**Private plan change to  
Auckland City Operative District Plan  
(Isthmus1999)**

**Proposed plan modification no. 210 : private plan change**

**Part A: Amendment to planning map no. G08 sheet no. 1**

<p><b>G08-15 CONCEPT PLAN – SELWYN HEIGHTS RETIREMENT VILLAGE, 42 HERD ROAD, HILLSBOROUGH</b></p>
---

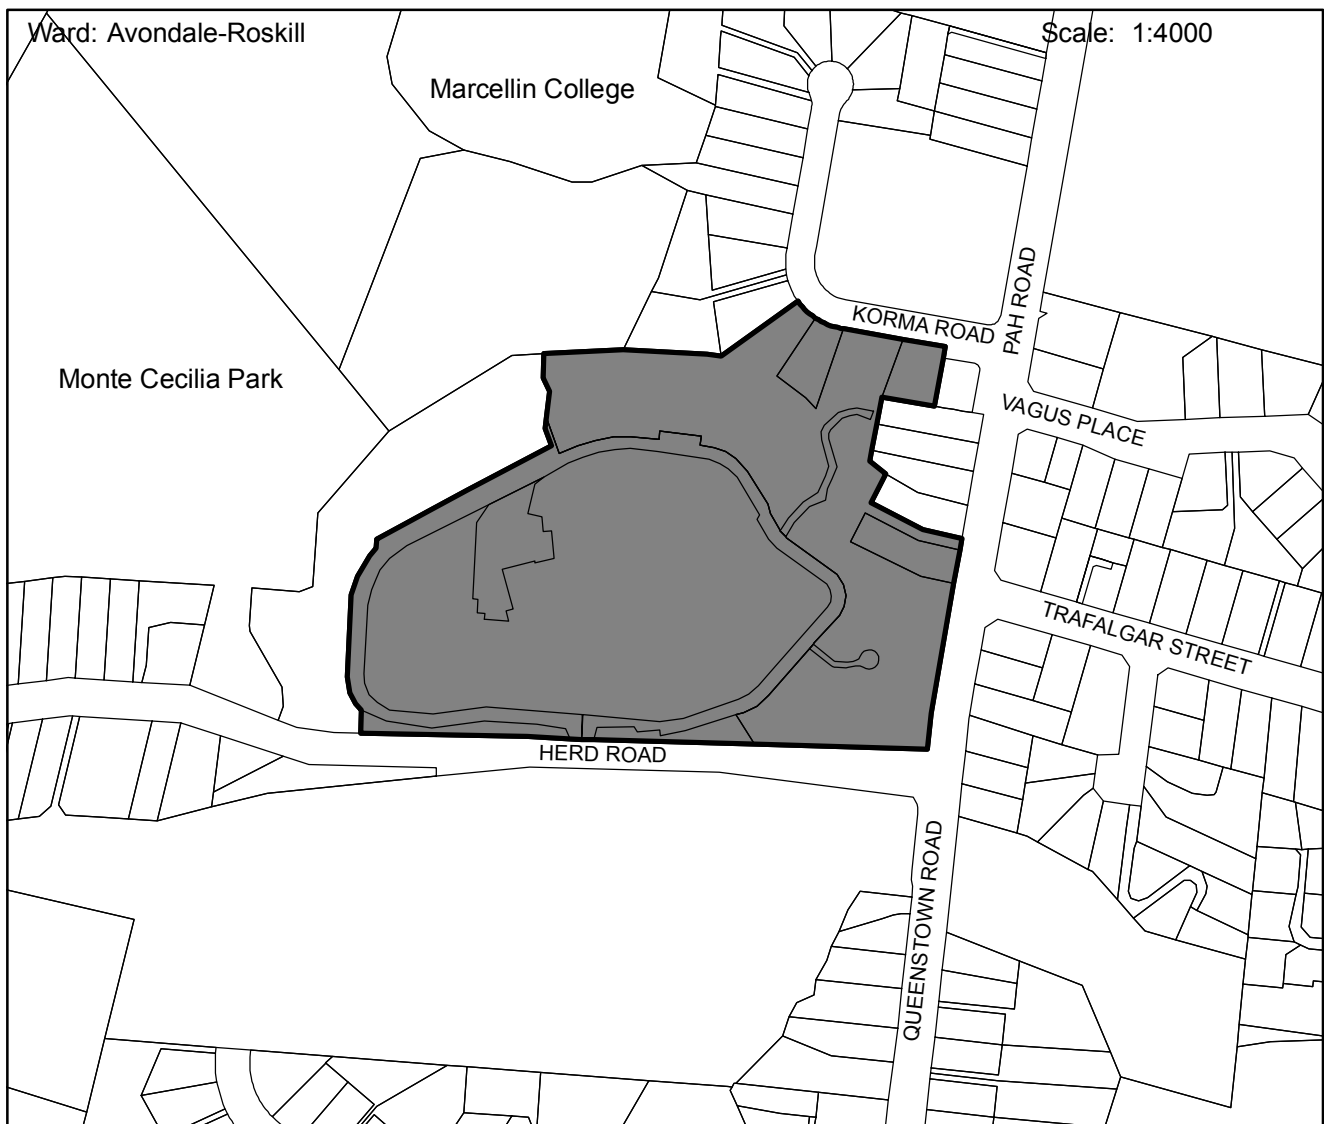
The land shown  to be rezoned from Residential 6a to Special Purpose 1

## Part B: Amendment to planning map no.G08 sheet no.2

The land shown  to be subject to additional limitation D05-07

**G08-15 Concept Plan Diagram - Special purpose 1 zone**

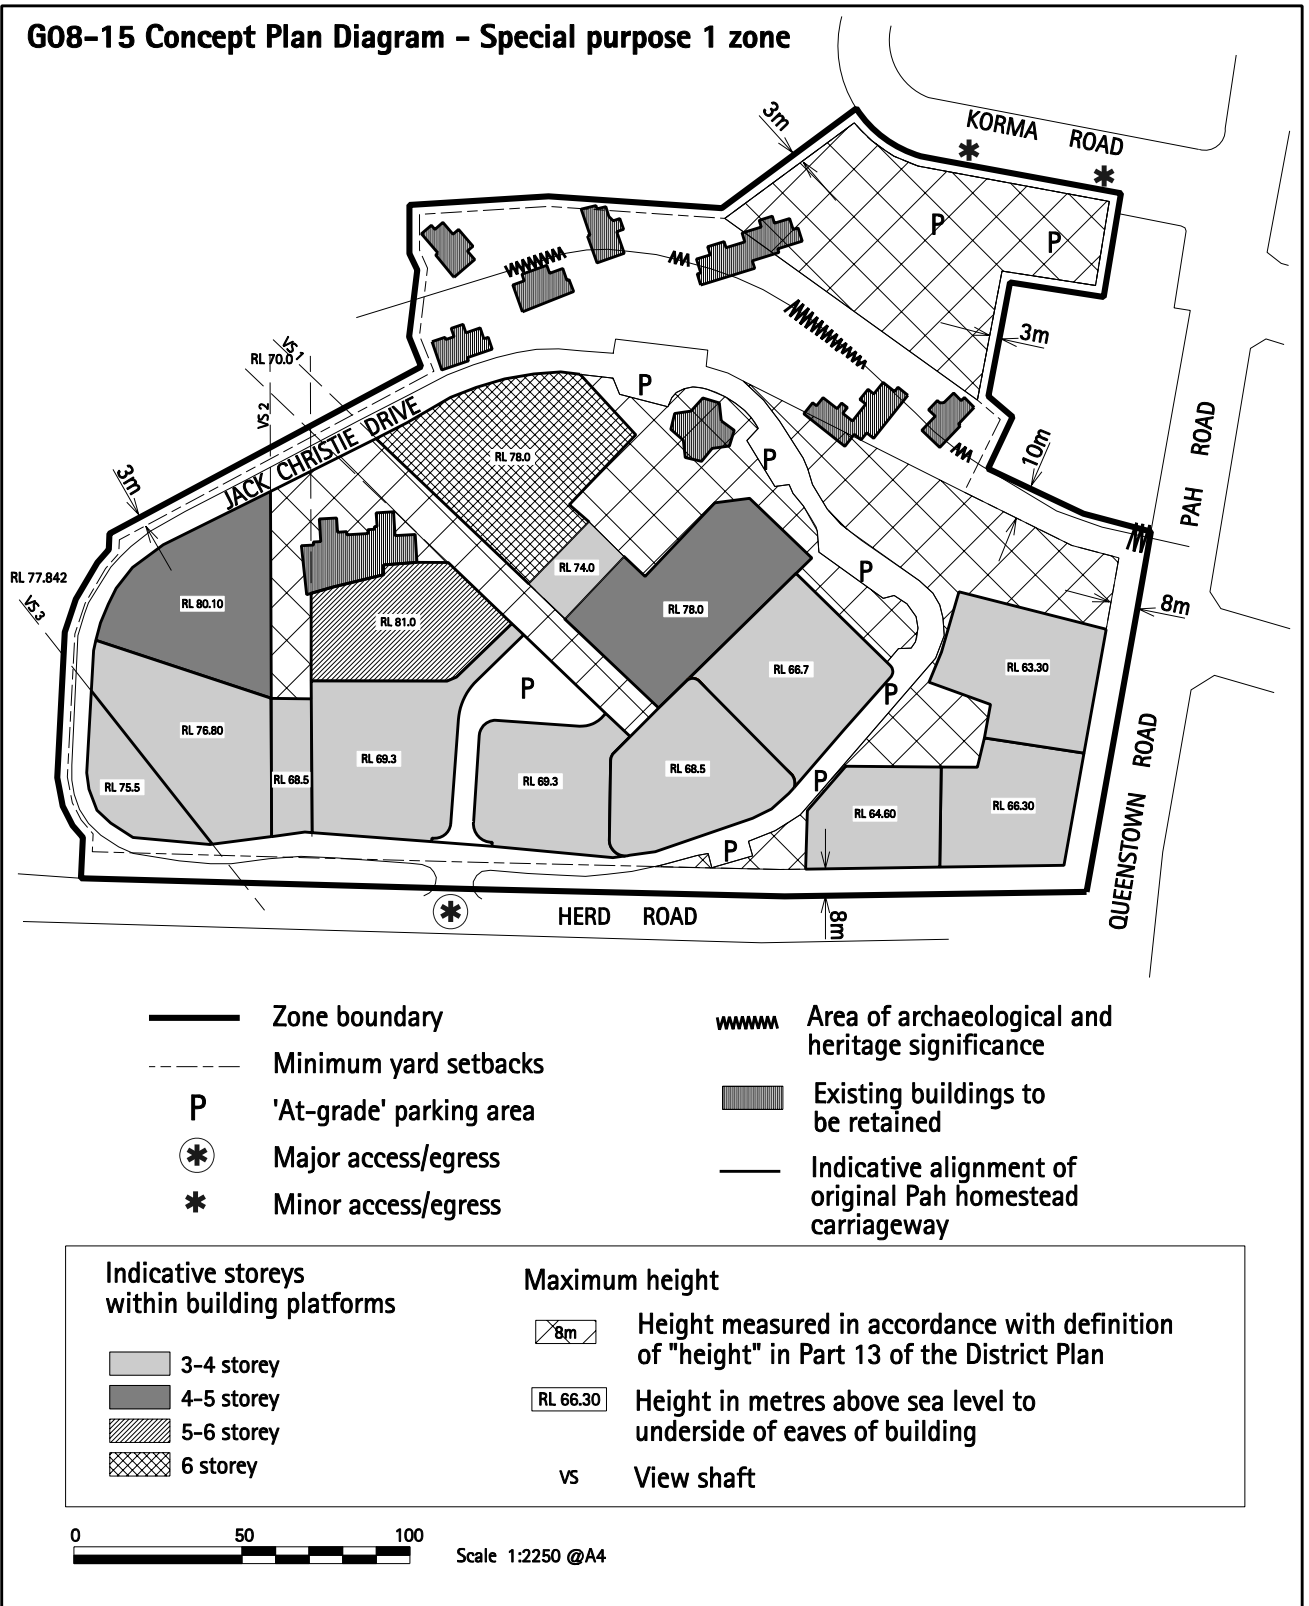
Building development is limited to those areas illustrated on Concept Plan Diagram G08-15.

The maximum heights are shown on the Concept Plan Diagram G08-15

With the exception of that part of the site identified on the Concept Plan as having an 8m height limit, the permitted heights identified on the Concept Plan relate to the height to the underside of eaves of prospective buildings, above which a further 3m height is provided for to accommodate roofs, machinery rooms/plant, lift and stair overruns (all being non-habitable floor space).

Yards shall be in accordance with the minimum dimensions shown on the Concept Plan Diagram G08-15 and shall be landscaped in accordance with Rule 4 above.

The location of the major and minor access/egress points are shown on Concept Plan Diagram G08-15.

More specifically the eastern and western vehicle crossings located on Korma Road are a maximum of 3m wide respectively.

The vehicle crossing to Herd Road is 12m wide: providing for a two lane (6m wide) egress; a single lane (4.5m wide) ingress; and a mid (pedestrian) refuge of 1.5m.

### G08-15(A) Concept Plan Diagram

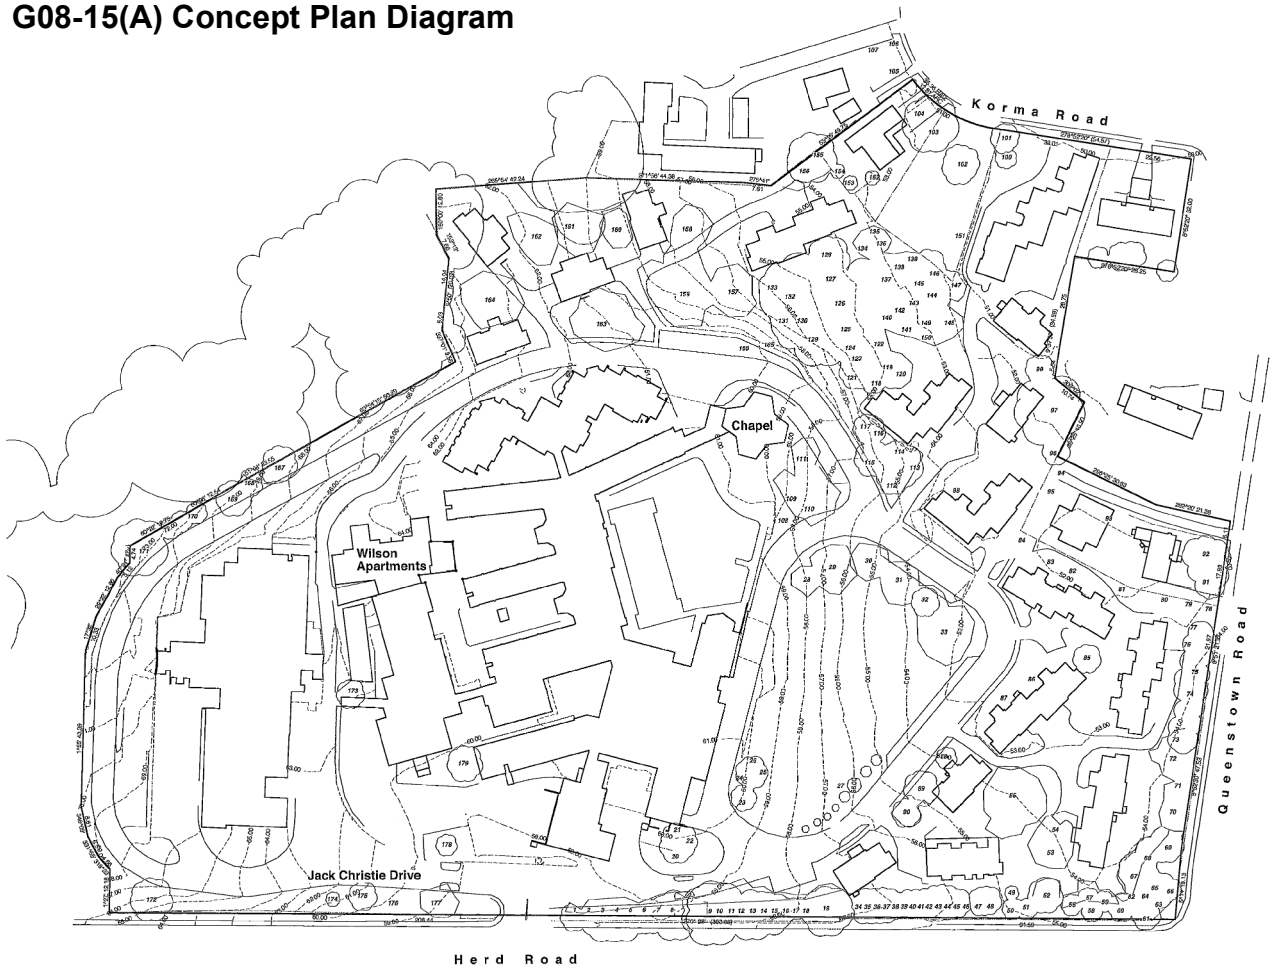
Trees proposed for removal, related to the numbering used in the Arborist's tree survey undertaken by Bevan Potts of IAC (and identified on the schedule to Concept Plan G08-15(A) is as follows:

Trees 1 to 8 inclusive, Japanese Cedar *Cryptomeria japonica*

Trees 34 to 48 inclusive, Japanese Cedar *Cryptomeria japonica*

Tree 61, Bottle Brush *Callistemon sp*

Tree 66 Coprosma *Coprosma repens*

Tree 70 Sheoak *Casuarina sp*

Tree 72 Flowering Gum *Eucalyptus ficifolia*

**G08-15(B) Areas of archaeological significance**

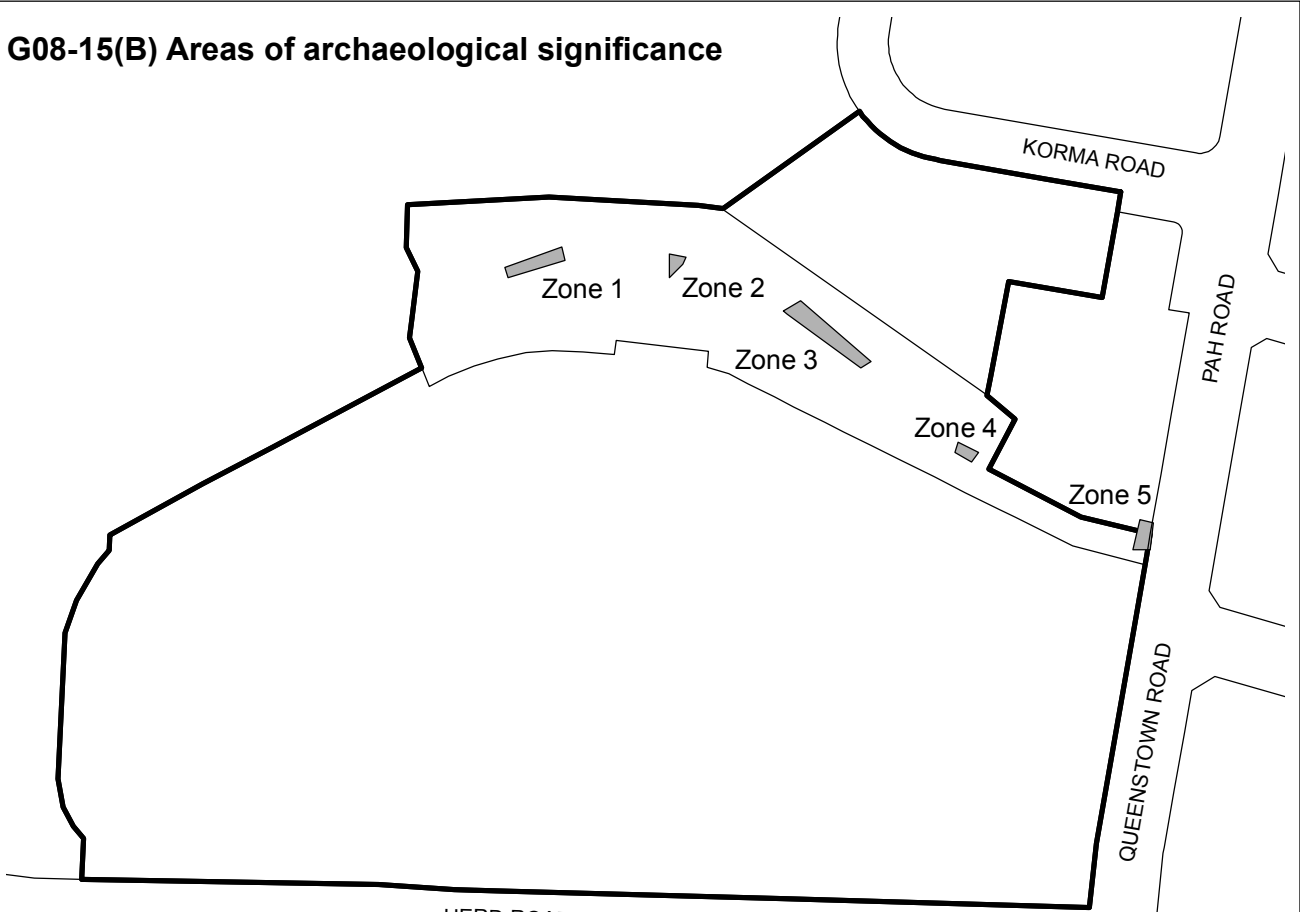
- Areas of archaeological significance
- Concept plan zone boundary

Zone 1	 Zone 2	 Zone 3	 Zone 4	 Zone 5
A 57 348 13 153	A 57 397 13 157	A 57 436 13 143	A 57 483 13 101	A 57 537 13 078
B 57 349 13 150	B 57 397 13 150	B 57 431 13 140	B 57 482 13 098	B 57 535 13 069
C 57 365 13 159	C 57 402 13 156	C 57 432 13 139	C 57 489 13 098	C 57 541 13 077
D 57 366 13 155	D 57 401 13 154	D 57 454 13 123	D 57 487 13 095	D 57 541 13 069
		E 57 457 13 125
